## **VENETIA STATION SUBDIVISION**

Based upon the preceding, the application is recommended for Holdover until the November 7, 2013 meeting, with revisions due by October 14, 2013 to address the following:

APPLICATION NUMBER 21 DATE October 3, 2013

# SITE PLAN

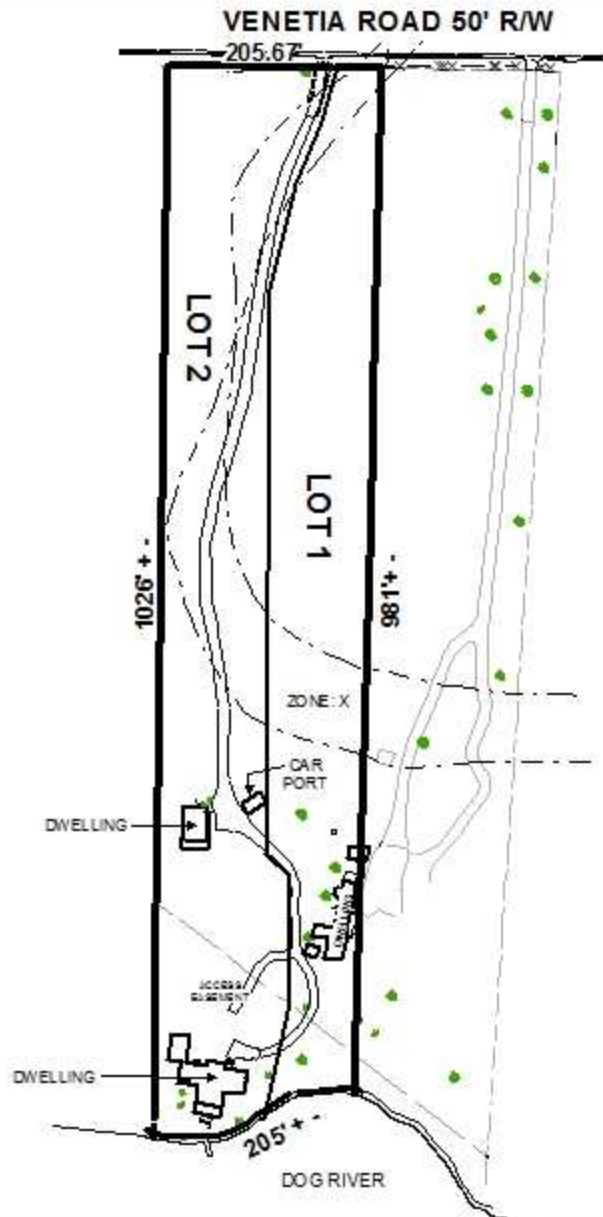
While this is a subdivision application there are Zoning Ordinance related issues that should be addressed. The plat displays property lines going through existing structures on the each site. It appears the existing carport on Lot 2 is encroaching onto Lot 1. The plat also depicts an existing garage located on Lot 1 encroaching onto the adjacent property. The proposed Lot 2 illustrates two dwelling units on a single building site which is not permitted in a Single Family Residential District. Furthermore, there is no nonconforming documentation on file regarding the existing multiple dwelling units. A rezoning application will be required for R-2 zoning or a variance to the Board of Zoning Adjustment. The plat also illustrates one driveway that appears to provide access to the three existing dwelling units located on the site. Because the site is located within the city, the Zoning Ordinance requires structures to be a minimum of 8' from the property line and a Planned Unit Development (PUD) is required to allow multiple structures on a single site, and to allow shared access. If approved, it should be noted the site would create several zoning violations.

The site plan also depicts a single family dwelling unit adjacent to the proposed Lot 1; however, it should be noted there is no longer a structure on the adjacent property. The property adjacent to Lot 1 should be included in the subdivision since shared access currently exists, and the encroachment of the garage onto the adjacent property. Revisions to the site plan to reflect all current structures shall be required.

The 25-foot minimum building setback line, required in Section V.D.9., is noted on the plat but not illustrated. Revisions should be made to depict the 25' minimum building setback line on the preliminary plat, and should be retained on the Final Plat, if approved.

- 1) revise site plan to depict property lines without going through structures;
- 2) revise site plan to depict 25' minimum building setback line;

- 3) provide nonconforming documentation to show multiple single family dwelling units existed prior to 1967 or submit a application to rezone property to R-2;
- 4) submit application for PUD;
- 5) include adjacent property to East in the PUD and Subdivision applications due to building encroachment across property lines and shared access;
- 6) submission of additional labels and fees due to expanded sub site; and
- 7) revisions to the site plan to reflect all current and existing structures;
